FINAL ENVIRONMENTAL IMPACT REPORT ENVIRONMENTAL IMPACT STATEMENT

PROPOSED CELERON / ALL AMERICAN AND GETTY PIPELINE PROJECTS

**CALIFORNIA STATE LANDS COMMISSION
AND
BUREAU OF LAND MANAGEMENT
DEPARTMENT OF THE INTERIOR**

Enclosed is a copy of the Finalizing Addendum for the Environmental Impact Report/Environmental Impact Statement on the following projects:

BLYTHE AREA MODIFICATION

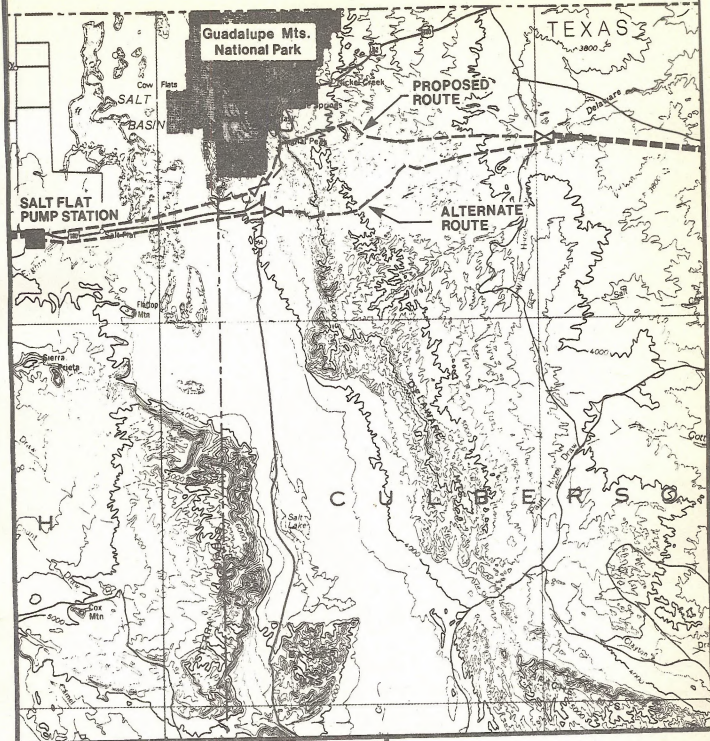
All American has modified its route near Blythe at the request of the Palo Verde Irrigation District and the City of Blythe to minimize potential impacts to cropland and irrigation practices. The alignment is shown on Map 3.3-3 (revised from the DEIR/EIS). The affected environment along the modified route is essentially the same as that along the original proposal.

Current farming practices in the Blythe area require deep tilling and ripping of soils. The modified route in the Blythe area was sited to minimize disruption of agriculture by paralleling existing roads and canals and greatly reducing diagonal crossing of fields. The long-term impact of the pipeline would be reduced, compared to the original route. Other land uses along the route are similar to those described previously. There would be two more crossings of the Midland Road than in the original route, but transportation impacts are not expected to be significant. Geology, soils, and hydrology concerns would be similar to those detailed for the original route. Since the area is primarily agricultural cropland, wildlife and cultural resources impacts would be minimal.
